TECHNICAL NOTE

5 WESTGATE MEWS, WEST END RESIDENTIAL DEVELOPMENT

Client: Macra Land Ltd
Reference: 2026-05-08-6785-TN01

1.1.1 This Technical Note (TN) has been prepared by Bright Plan on behalf of Macra Land Ltd to support appeal proceedings for an application at 5 Westgate Mews, West End (planning ref: F/26/100809).

Estate Cars Passing & Inter-visibility

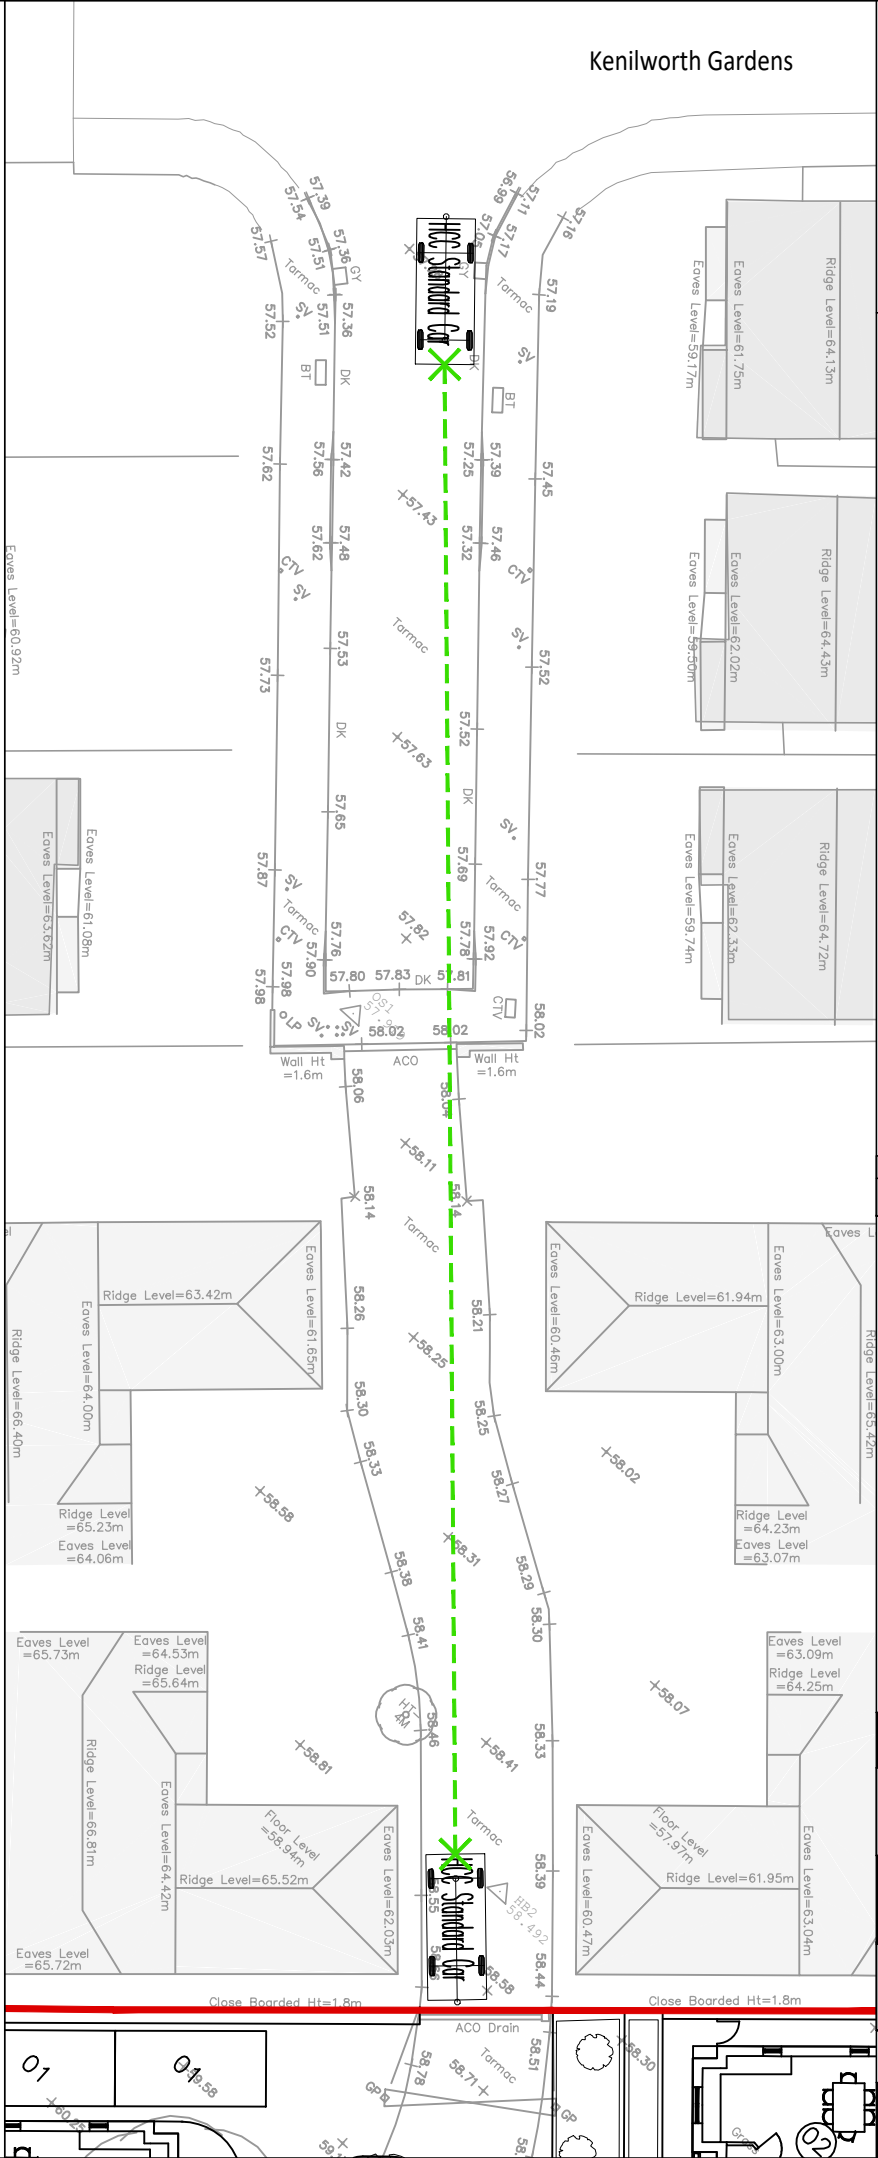
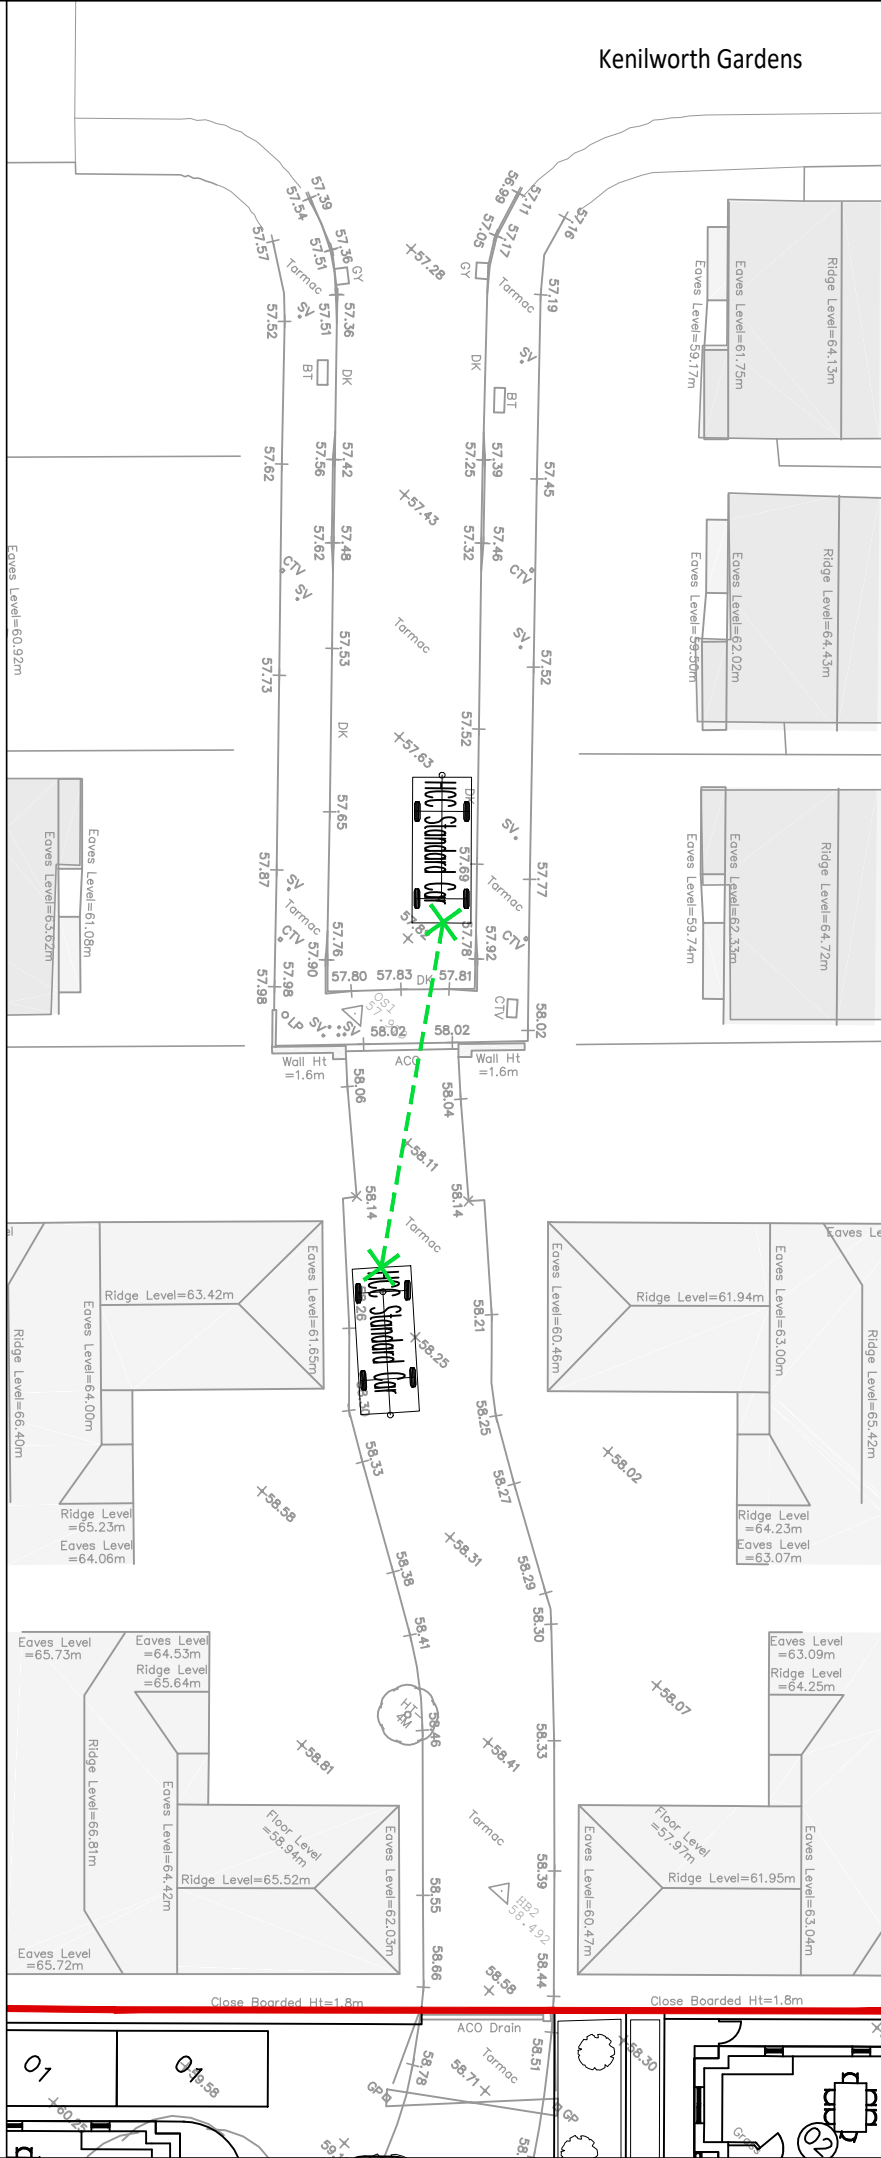
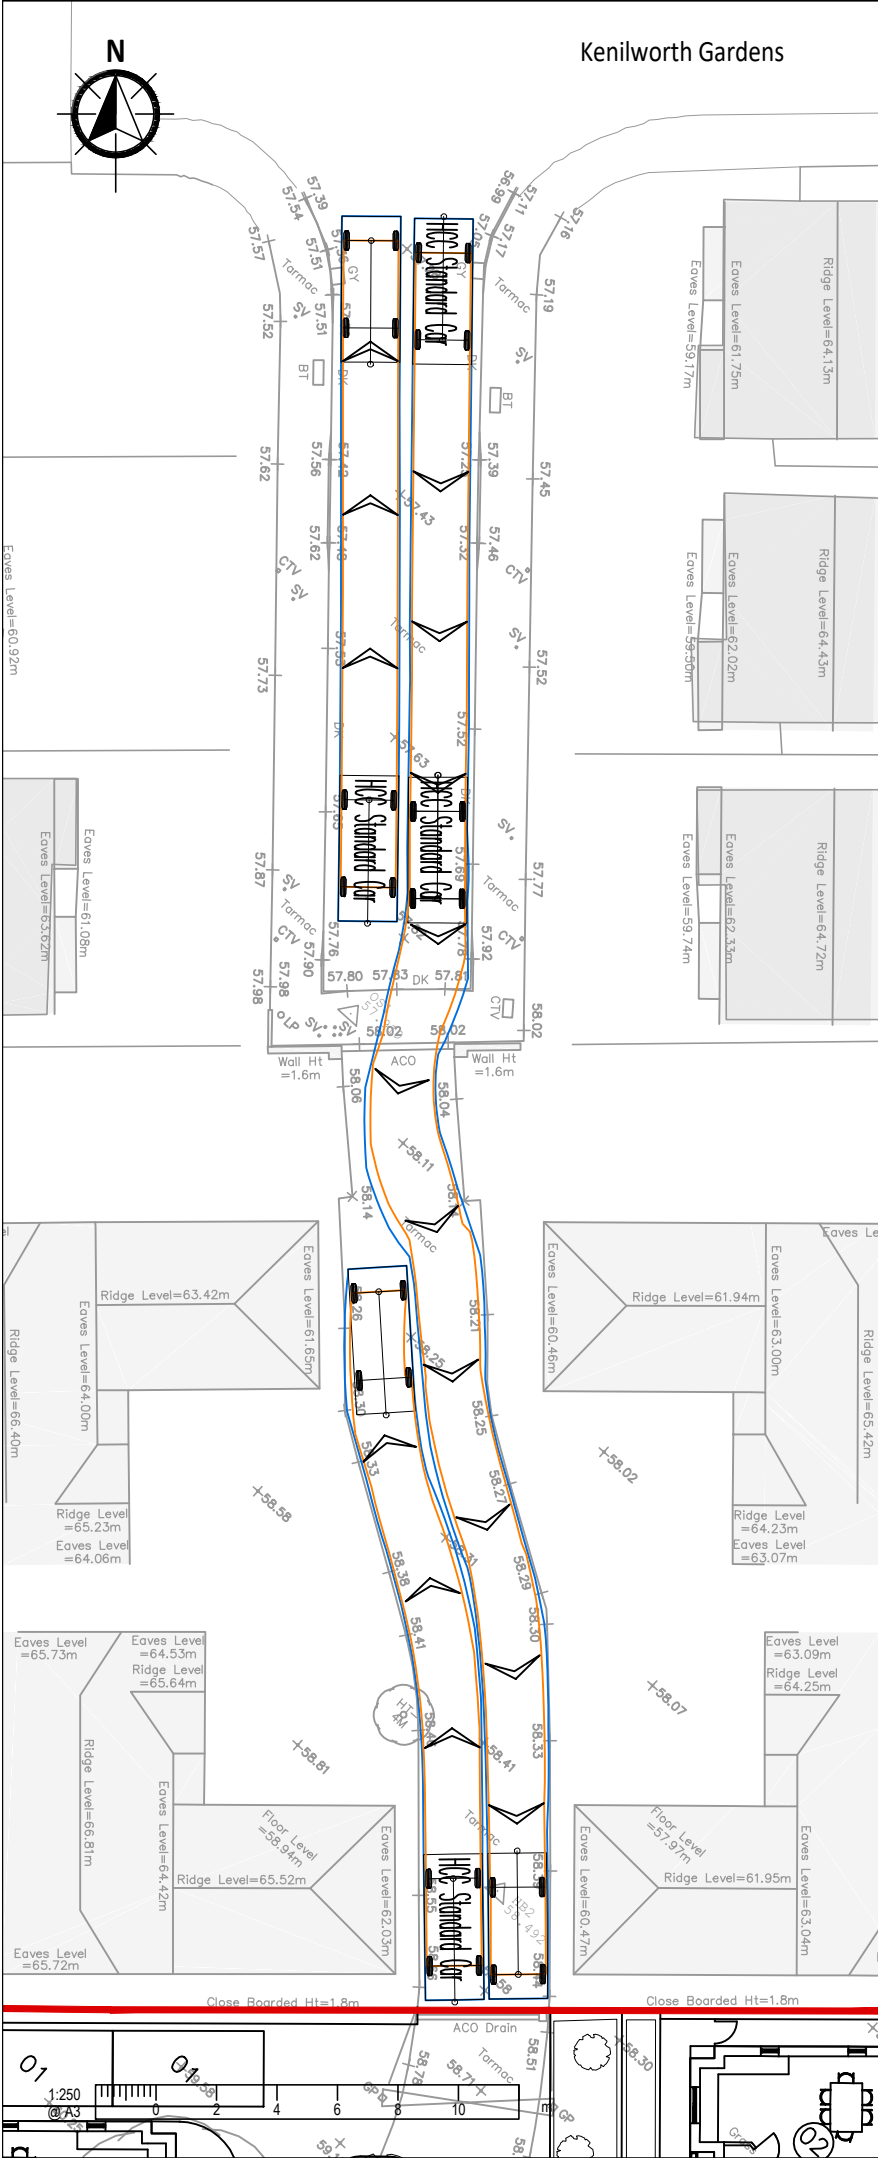
This access is therefore acceptable in principle, however it would be requested that additional vehicle tracking drawings are provided which show two-way family car movements through the access point between Kenilworth Gardens and Westgate Mews as this looks tight.

Whilst it may be an existing situation, only 4 dwellings currently utilise the access and as such there is little chance of conflicting movements requiring a vehicle to reverse onto the highway to allow another to exit Westgate Mews.

With the increased dwelling numbers however, the potential for such instances would be expected to rise accordingly which would not be welcomed."

2.1.1 A vehicle swept path analysis has been undertaken demonstrating manoeuvres at the access onto Kenilworth Gardens, as requested by HCC. The brick piers at the end of Westgate Mews are spaced 3.7m apart, and this width continues for 5.0m, before widening to a width of 4.7m. The 3.7m width prevents two-way passing of cars, however two-way passing is achievable on Westgate Mews past this point, as well as on Kenilworth Gardens.

2.1.2 However, inter-visibility between vehicles departing/arriving at the site is clear both in the immediate vicinity of the access, and from points well back on both Kenilworth Gardens and Westgate Mews. As such, drivers are readily able to see another vehicle approaching, meaning drivers can give way where necessary, with no need for an arriving vehicle to reverse on the public highway. **Drawing 2024-6785-006** demonstrates manoeuvres on Kenilworth Gardens and Westgate Mews, as well as inter-visibility between drivers arriving at and departing Westgate Mews.

4.1.1 A vehicle swept path analysis has been undertaken demonstrating two-way passing on Westgate Mews and Kenilworth Gardens. Whilst two-way passing is not achievable for a 5.0m section through the access, an assessment of the vehicle trip generation demonstrates a very low likelihood of vehicles encountering one another at the access point.

- 4.1.2 In the rare event that vehicles do approach simultaneously, there is good inter-visibility between Westgate Mews and Kenilworth Gardens, meaning drivers would be able to give-way, and there would be no need for vehicles to reverse on either Kenilworth Gardens or Westgate Mews.
